BOLINGBROKE JSP17-34

Consideration at the request of Singh Development, LLC for approval of Preliminary Site Plan, Site Condominium, Woodland Permit, and Stormwater Management Plan. The subject property is located in Section 10 at the intersection of Novi and Old Novi Roads, north of 12½ Mile Road and is zoned R-4, One Family Residential. The applicant is proposing to develop the 19.78 acre parcel to 46 single-family, detached residential site condominiums. The public hearing was held on June 14, 2017.

PLAN REVIEW CENTER REPORT

Review Date: April 19, 2017
Review Type: Preliminary/Final Site Plan
Project Name: JSP17-34 Bolingbroke
Plan Date: 3-30-2017
Prepared by: Kirsten Mellem, Planner
Contact: **E-mail:** kmellem@cityofnovi.org **Phone:** 248-347-0484

SHEET 1

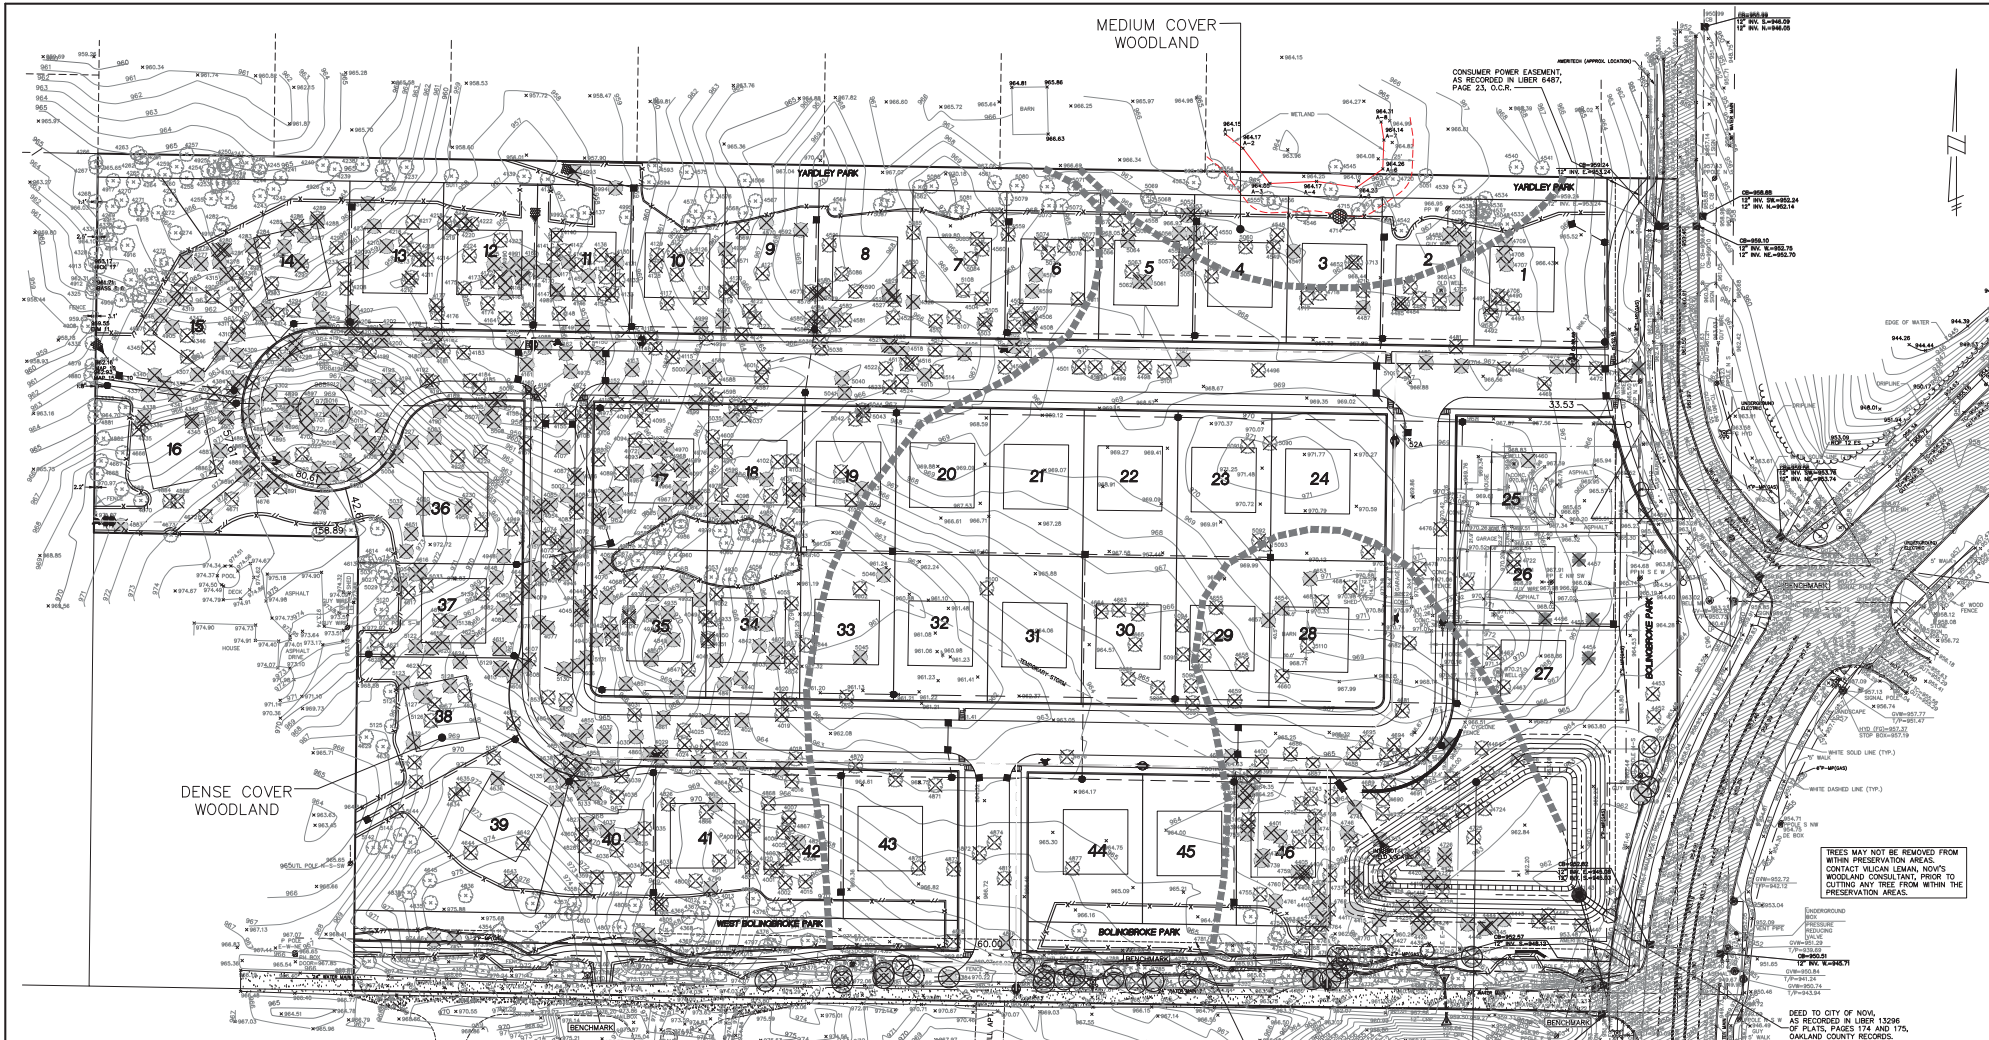
11. Revise note on Sheet 1 to indicate connection to existing 8" sanitary sewer.
12. The sanitary segments 14-6 and 13A-13 shall have a slope of 0.60% since they are the furthest upstream segments without additional contributing flows. The stubs to the west shall have a slope of 1.0%.
13. Raise proposed upstream invert at structure 3 to be 0.1 feet higher than existing downstream invert.
14. Label the water main and storm sewer crossings upstream of structure 9.
15. Raise proposed rim elevation of structure 3 to ensure positive drainage.

1. Development Standards – The lot data table now shown on sheet 1 of the site plan will be expanded to include setbacks, lot depth, lot width and depth to width ratio.
2. The Master Deed will be provided with the Stamping Sets.
3. None of the lots contain wetlands. A conservation easement for the wetland setback area will be provided along the rear lot line (north property line) of lots 2, 3 and 4.

LS-1 of 7

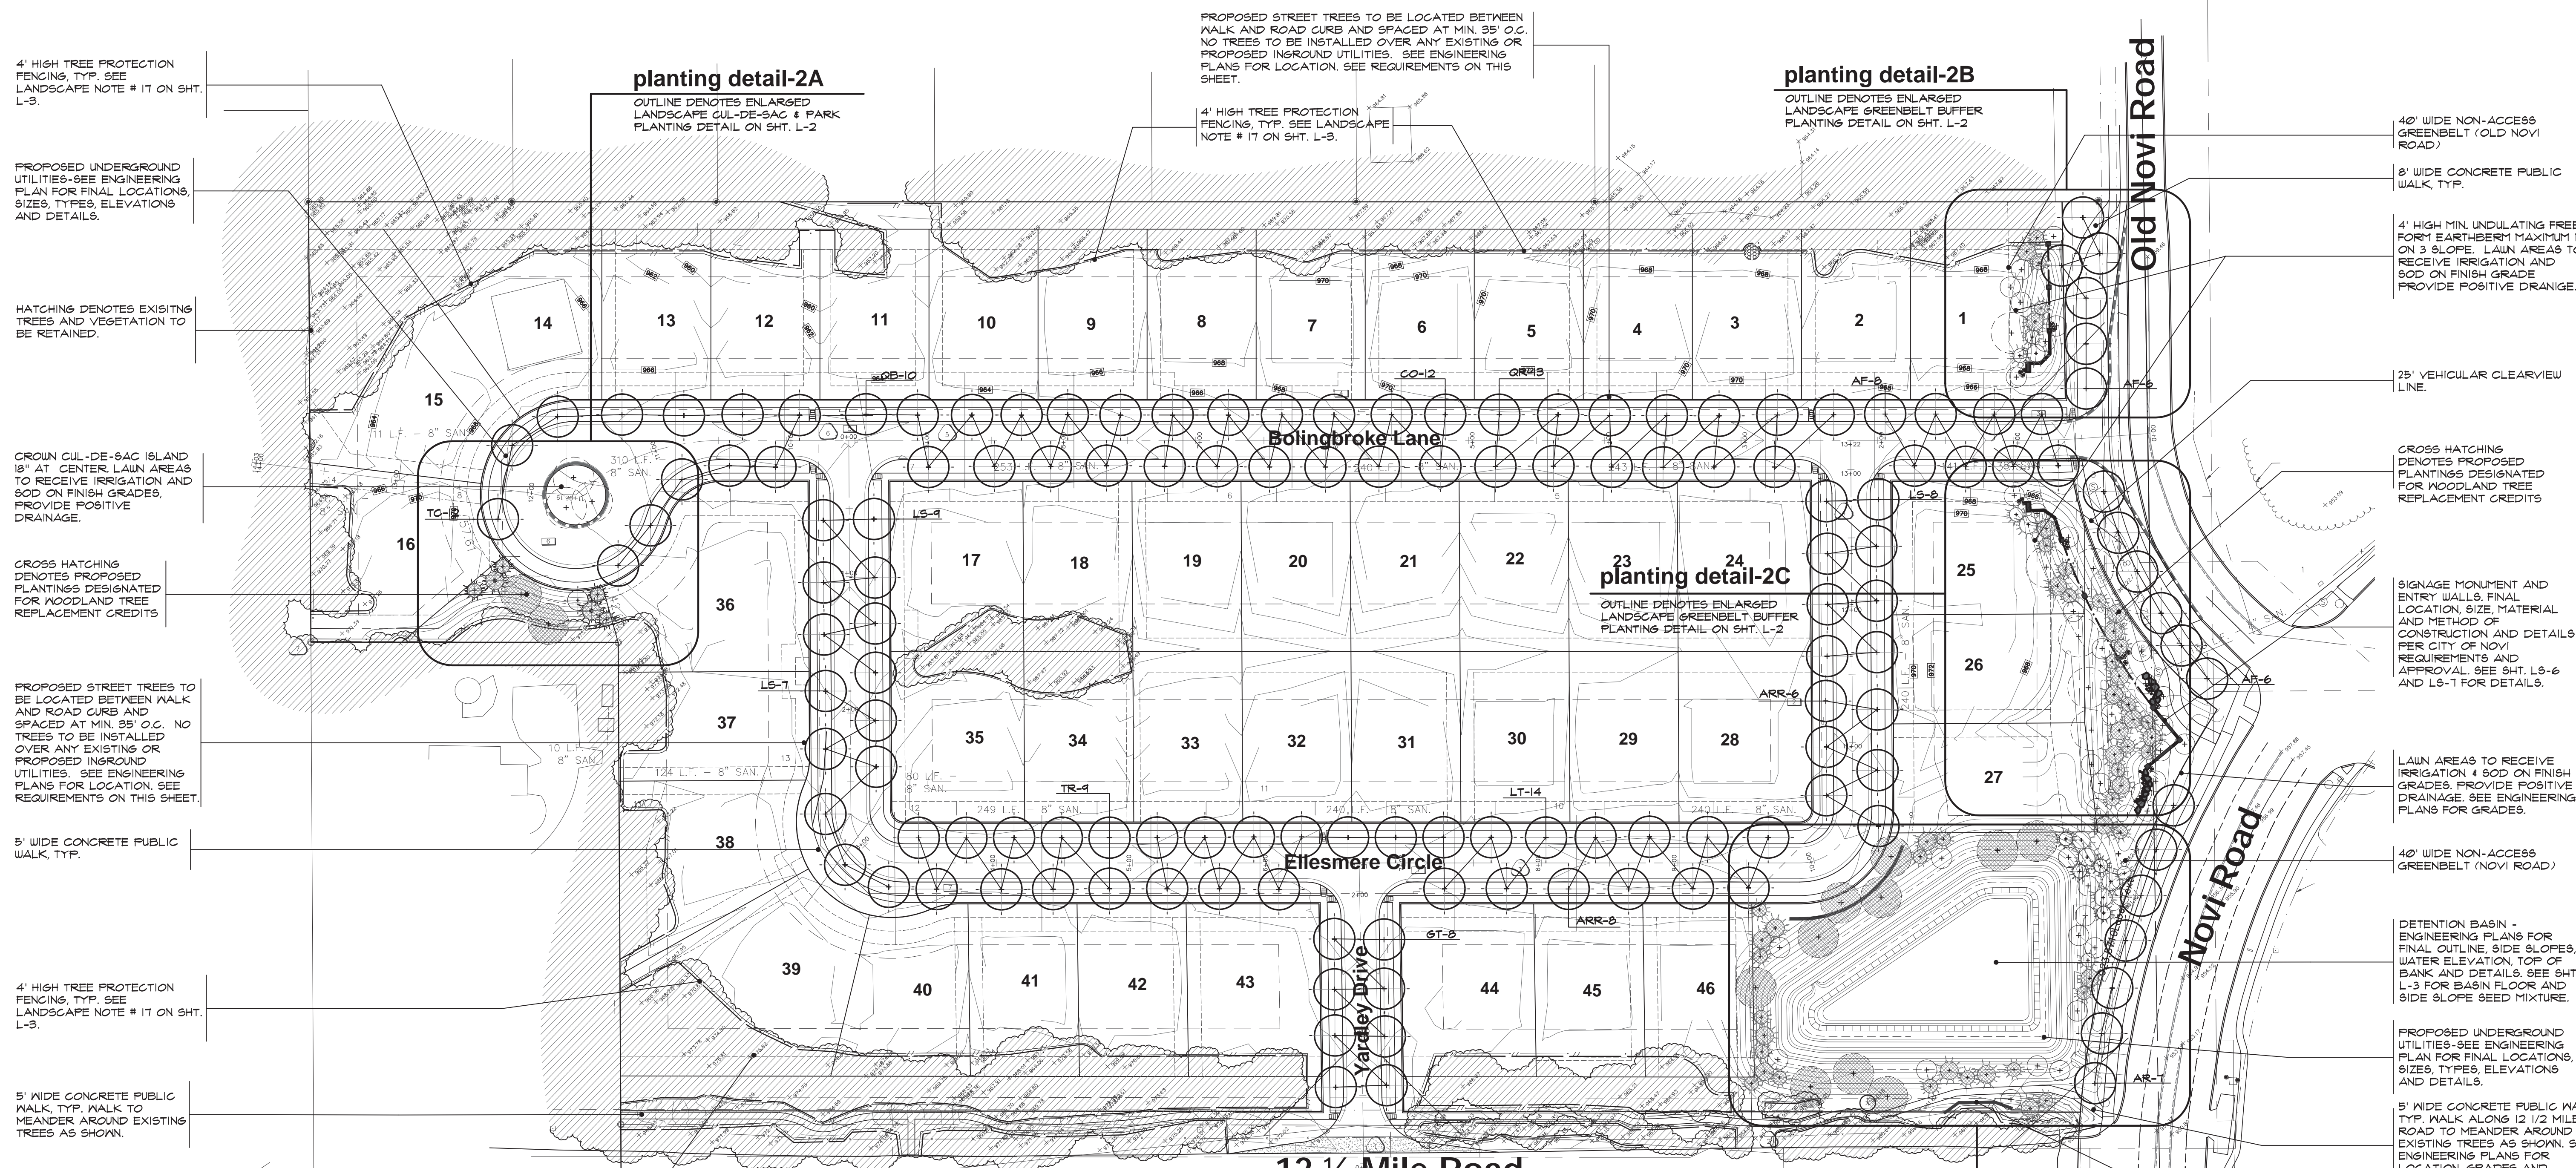
1. The applicant is requesting a landscape waiver for the berm in order to preserve the existing natural landscape. As part of this waiver, the berm and required landscaping are not provided. A site visit revealed this area to have a good number of native trees of varying sizes, and a good number of wildflowers in the greenbelt. Because of this growth, the waiver is supported by staff.
2. **The waiver request should include the extent of berms and landscaping not provided and be listed on either the plan set cover sheet or Sheet LS1 with all other waivers requested.**

4. Lots – Based on the lots' frontages, 114 street trees are required, and 120 are provided.
5. The clear vision zones called for in Section 5.9 should be provided for all street intersections, including interior intersections. Trees cannot be placed within those zones. If the required number of street trees cannot be located along the roads because of these clear vision zones, the applicant may request a landscape waiver for the trees that can't be planted for this reason. **The waiver should be included in the list mentioned above.**
